Abbreviated Notice of Resource Area Delineation-Peer Review

Map 6, Block 2, Lot 2.2 DEP File Number 114-1235

Photo of potential Vernal Pool in the Vicinity of Wetland Flags L13 – L15

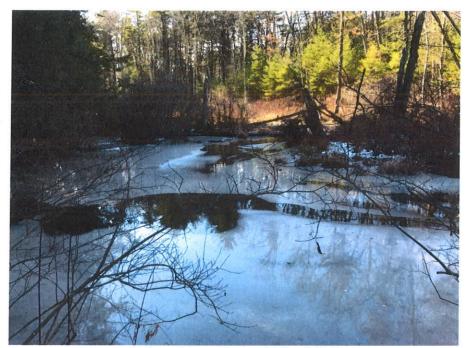
During our November 11, 2016 site visit with WPI we reviewed the delineated boundaries of the vernal pools and agreed with the flag locations. We questioned whether or not an impoundment in the vicinity of wetland flags L13-L15 was a vernal pool, (see attached photo). We have not heard back from the applicant's representative regarding this area.
